45 Richmond St
Map 108 Lot 18

Change to the size of Greenhouse within the Rear Yard Setback

REVISED GREENHOUSE PLAN

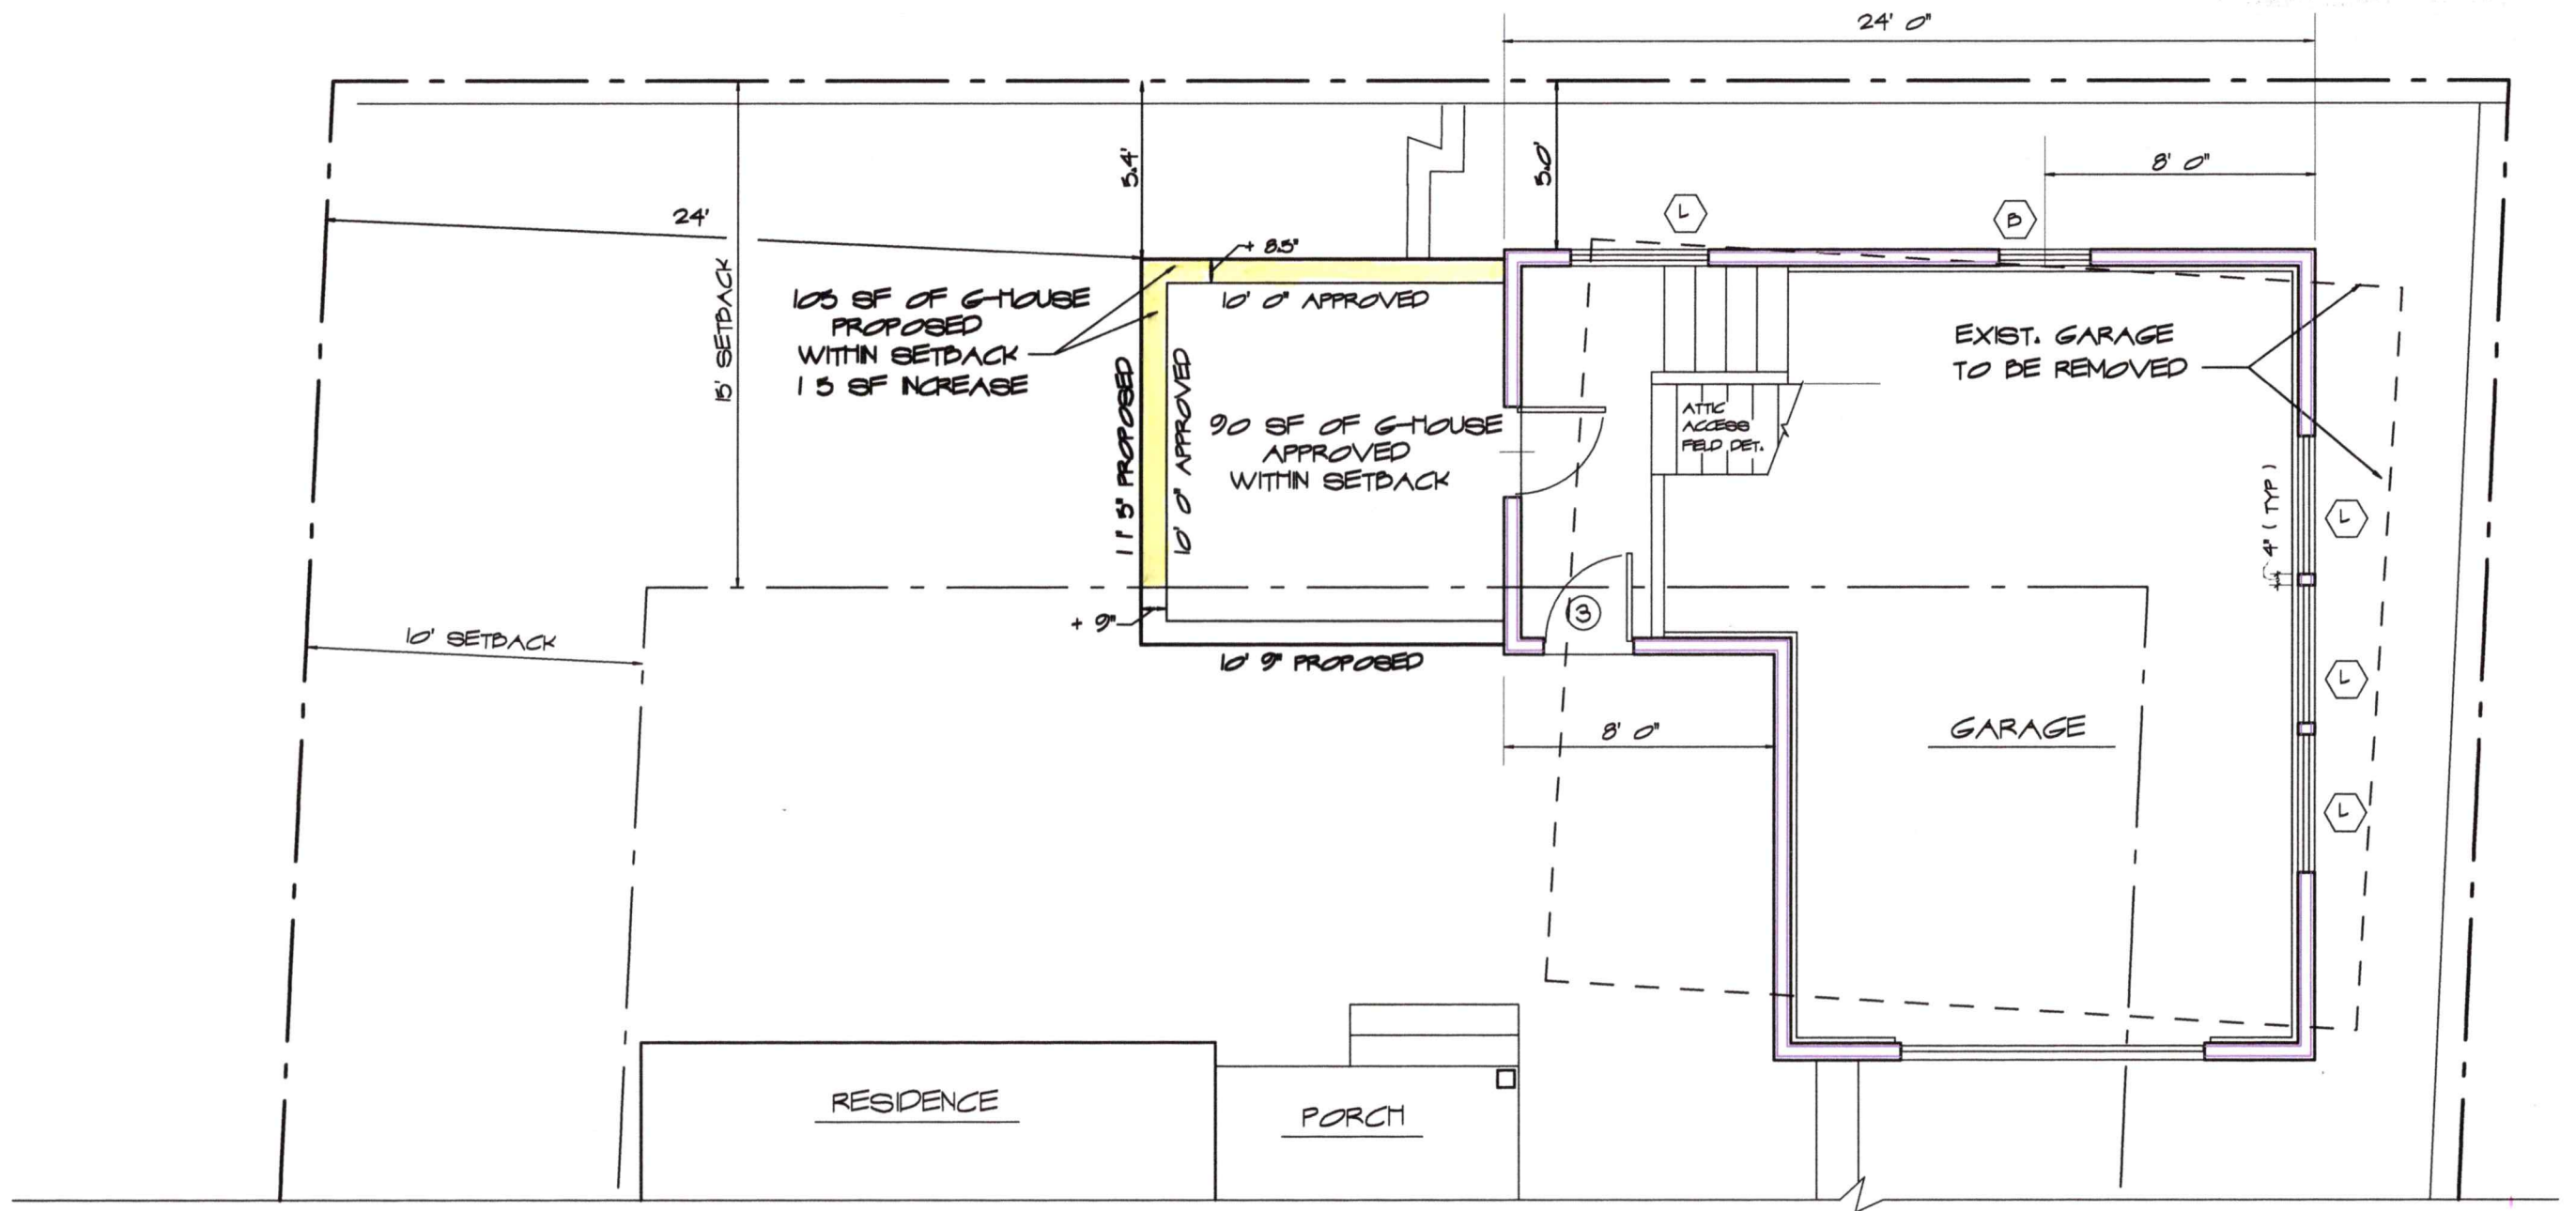
1. An increase of 15sf within the Rear Yard Setback, for the Greenhouse

1. A Greenhouse (10' x 10") was previously approved within the rear yard setback, Jan. 21st 2021. There was a stipulation that both the Garage & Attached Greenhouse will have a minimum rear setback of 5ft. The Proposed Greenhouse has a 5.4' setback.
2. Working with the Greenhouse Supplier, we found that the standard glass size at 30" determines the overall size. The closest standard size is 11' 3" x 10' 6", with the foundation needing to be 11' 5" x 10' 9". This adds 15sf within the rear yard setback. The added 9" of length still leaves a 24ft Left Side Setback.

NOTE: GREENHOUSE SIZE HAS CHANGED FROM 10' X 10',
 TO CONFORM TO MANUFACTURERS STANDARD SIZING, 11' 3" X 10' 6" (118 SF)
 FROST WALL & SLAB DIMESIONS INCREASE TO, 11' 5" X 10' 9" (123 SF)
 SLAB DIMENSIONS USED TO CALCULATE AREA WITHIN THE REAR SETBACK

SITE PLAN **C3**

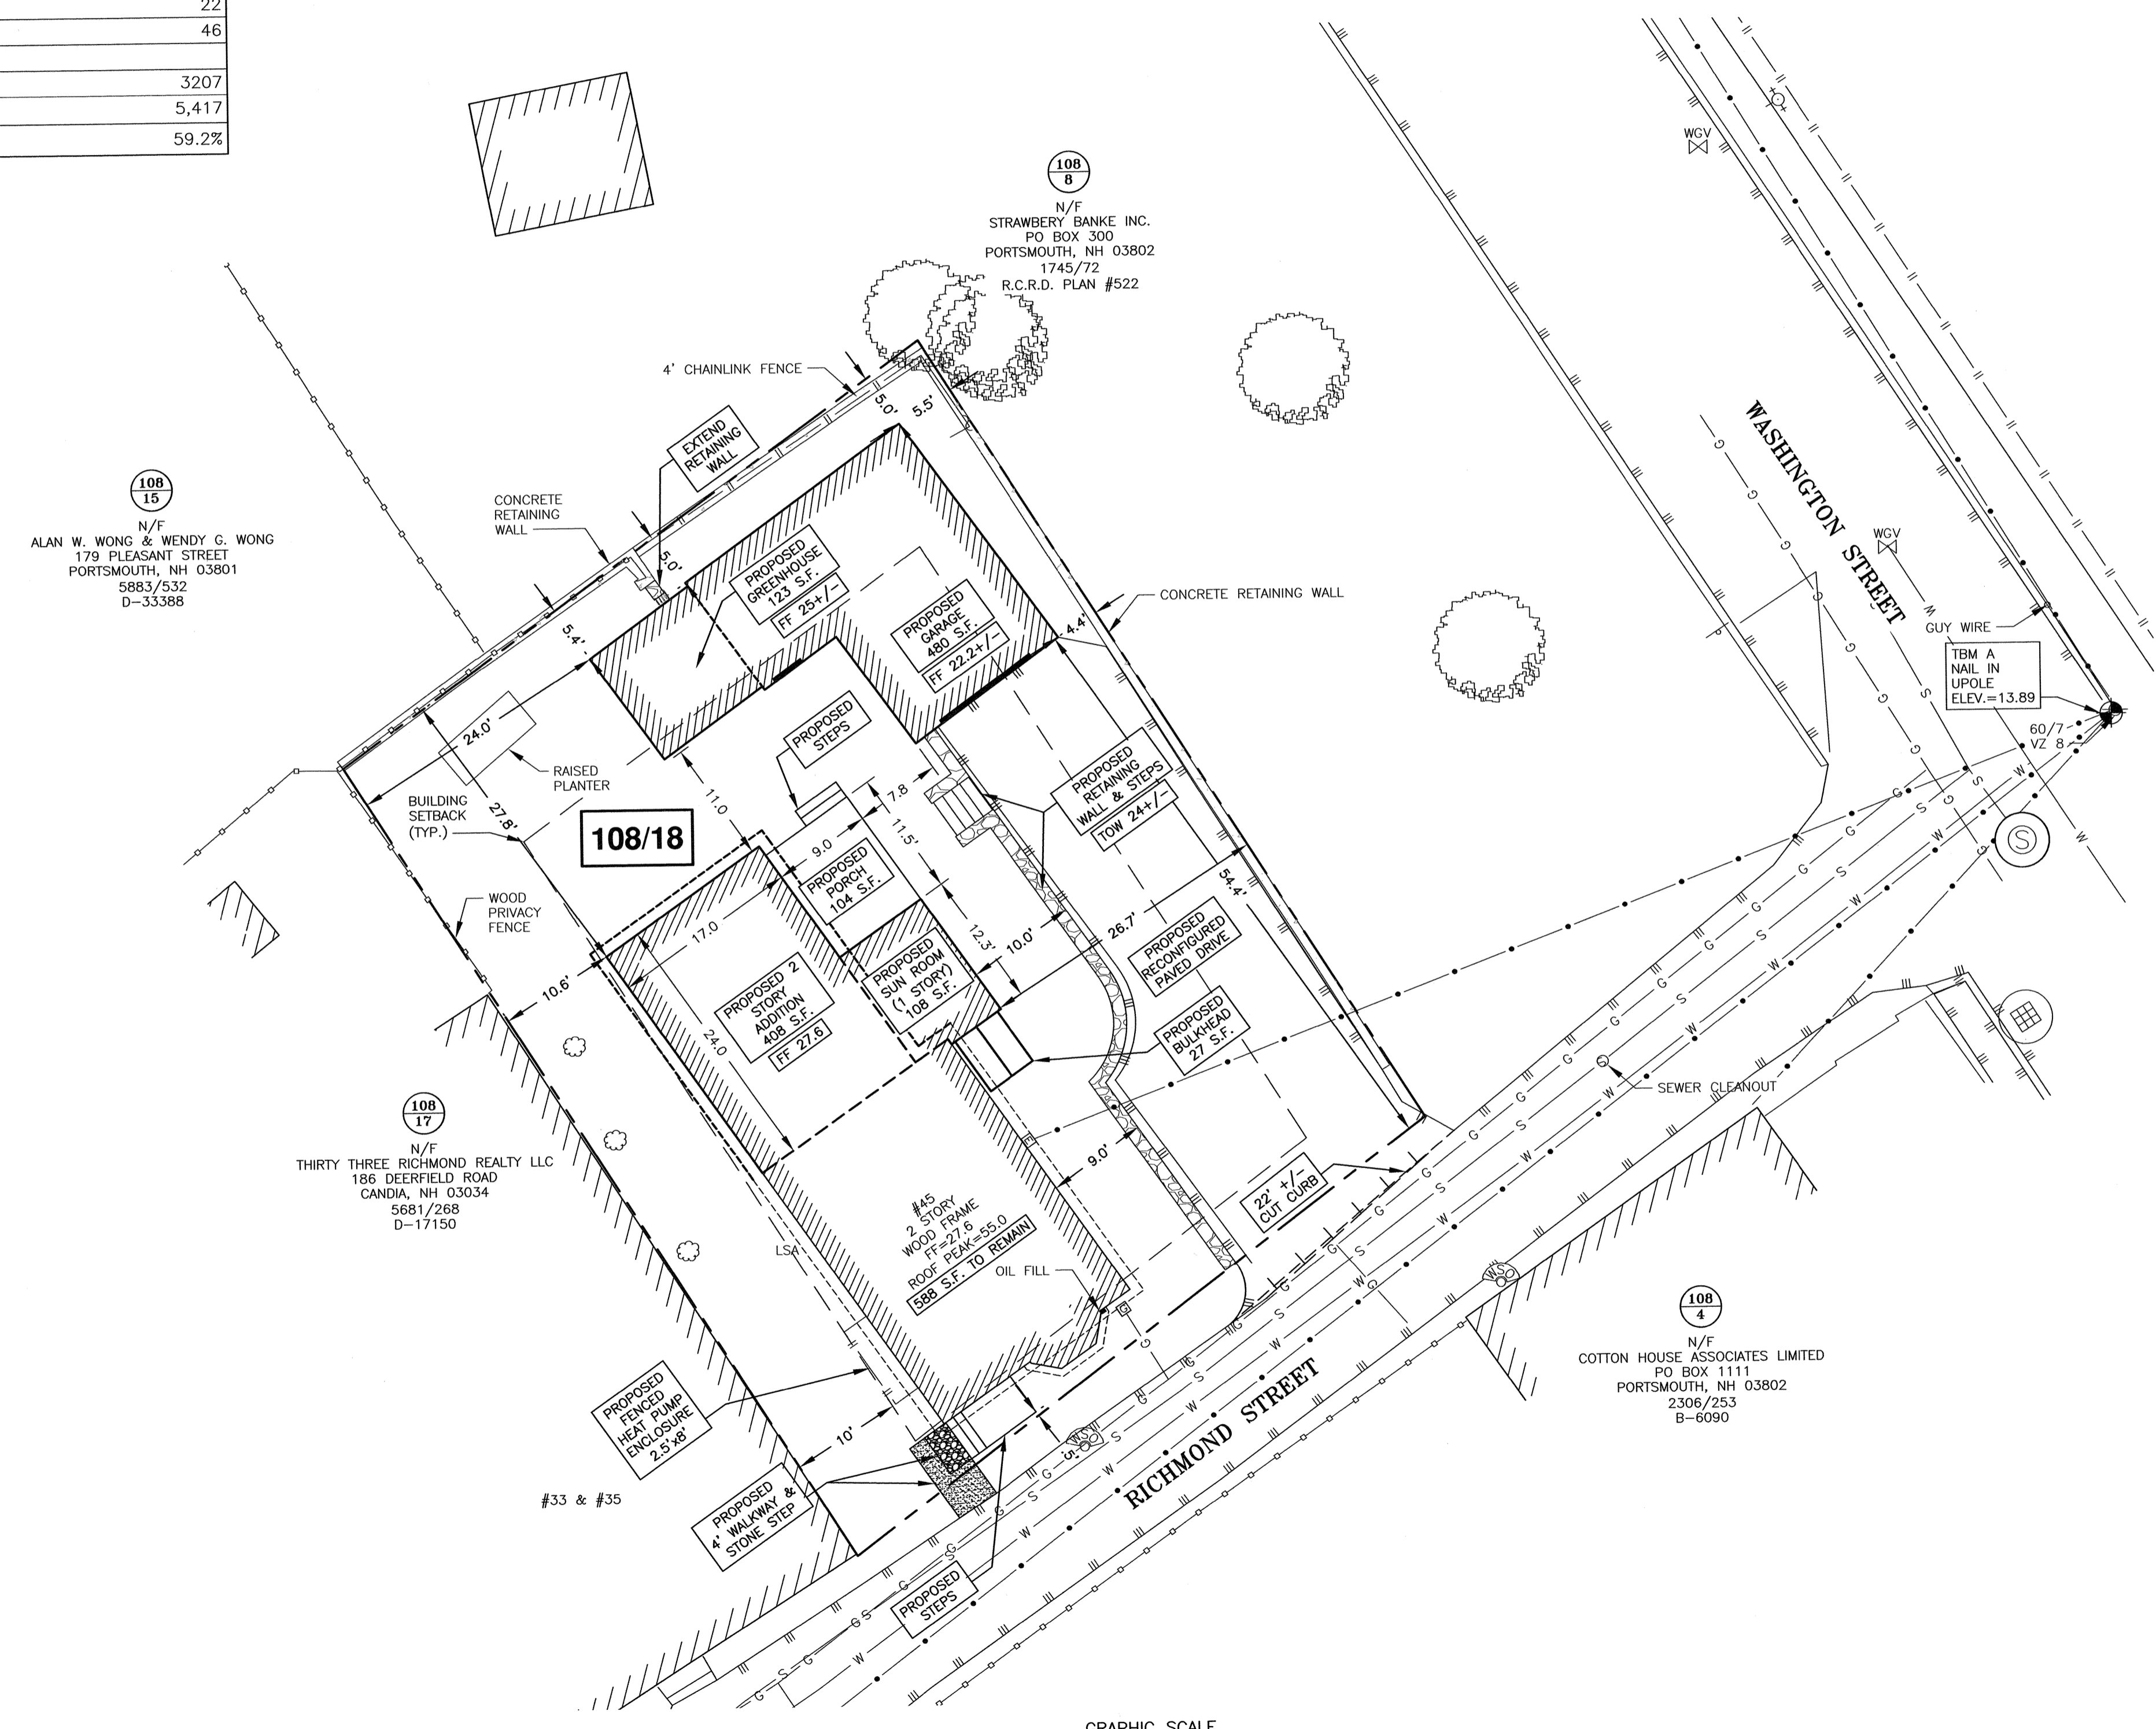
NO.	DESCRIPTION	DATE
2	REVISE BUILDING	2/16/23
1	ISSUED FOR APPROVAL	12/8/20
0	ISSUED FOR COMMENT	11/23/20
